Item 4.**Development Application: 25-27 Dunning Avenue, Rosebery - D/2021/1491****File No.: D/2021/1491****Summary**

Date of Submission:	4 January 2022
Applicant:	Mr R Macauley
Architect/Designer:	Tzannes
Owner:	Dunning Proprietor Pty Ltd.
Planning Consultant:	Gyde Consulting
Heritage Consultant:	GBA Heritage Pty Ltd.
Cost of Works:	\$7,733,000
Zoning:	B4 Mixed Use. Commercial premises is permissible with consent within zone.
Proposal Summary:	<p>The proposal involves the conversion of a two storey heritage listed warehouse building, into a five storey commercial development. This includes internal alterations and the addition of three levels, upper level outdoor terraces and 10 at grade car parking spaces utilising an existing driveway from Cressy Street.</p> <p>The existing warehouse is a heritage listed item number I1376 'Paradise Garage' under the Sydney Local Environmental Plan (SLEP) 2012.</p> <p>The site includes a base Floor Space Ratio (FSR) of 1.5:1 with a potential bonus of 0.5:1 for the delivery of community infrastructure. Additional floor space is also allowed for the inclusion of end of trip facilities which is included in FSR. The development therefore has a potent

Figure 5: Interior images of the showroom, workshop and first floor mezzanine level. All items are proposed to be demolished or altered as a result of the proposal.

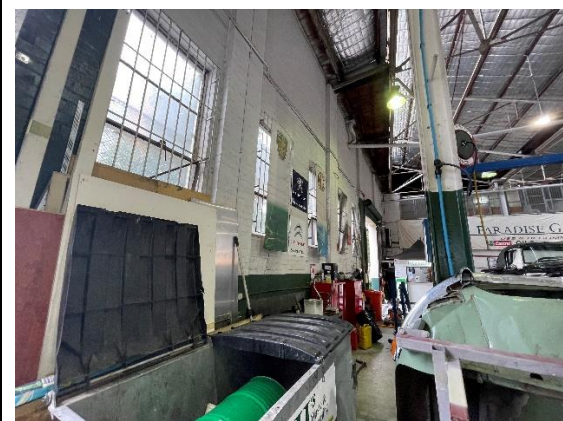
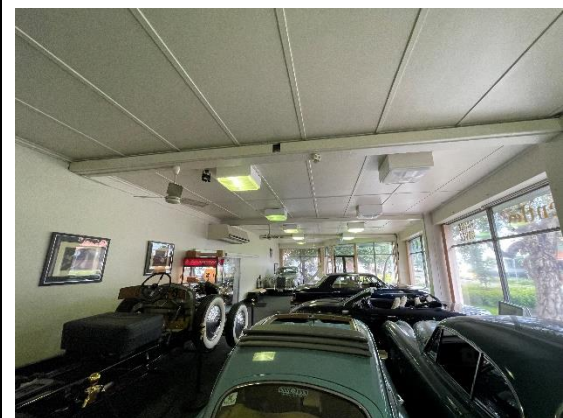
Existing interior workshop showing saw-tooth roof proposed to be removed

Existing openings and vertical steel columns which are proposed to be removed and altered.

Ground floor showroom to be removed looking towards the corner entry on Dunning Avenue and Cressy Street.

First floor mezzanine level offices to be demolished.

Figure 22: Cressy Street frontage amendments

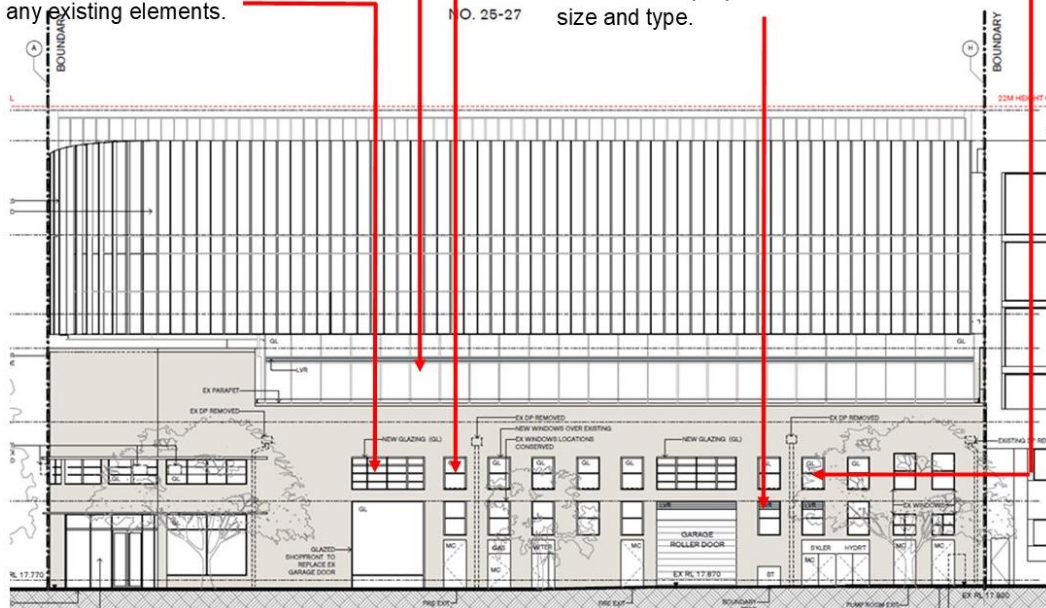
New glazing treatments not part of the existing façade and not consistent with any existing elements.

Windows are proposed to be altered in size and type.

35. The removal of openings is not supported as they are significant fabric. The insertion of new windows alters the heritage significance and architectural language of the post war building. The creation of new lower level first floor requires the alteration of windows, incorporates new openings for the first floor and removes almost all of the internal steel trusses. Such significant alterations substantially and unreasonably diminish the heritage significance of the building.

Figure 24: View from Level 6 - Roof top of adjacent residential building 29-31 Dunning Avenue (image provided by a submitter)

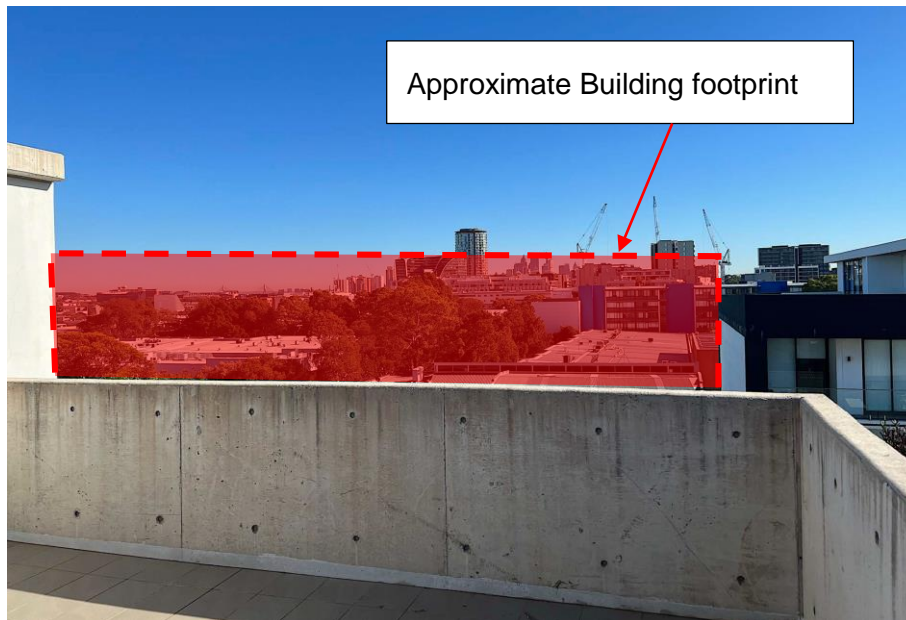
- (b) Amenity Impacts - Adjoining development
- (i) View Loss Analysis
- A view loss assessment has been completed by the proponent as part of the submitted SEE for No. 29-31 Dunning Avenue. A review of the assessment indicates that No. 29-31 Dunning Avenue will be negatively affected by the proposal with a loss of view to the city skyline, however, the analysis was conducted up to level 5 and the neighbouring building has a roof-top access which is level 6, figure 24 below.
 - It is accepted that views to the city skyline will be interrupted by future development in the precinct located north of the apartments at 29-31 Dunning Avenue. However, given the massing and that the FSR remains significantly non-compliant view loss created by the development is considered unreasonable.

- As noted in the report, approved nearby developments to south-east and north of the subject site are provided with compliant FSR and do not contain heritage items on site. Therefore proposal with compliant FSR and greater heritage preservation in conjunction with the controls, would result in a building envelope with reduced bulk and scale and would have a reduced impact on the view loss from developments south of the subject site.
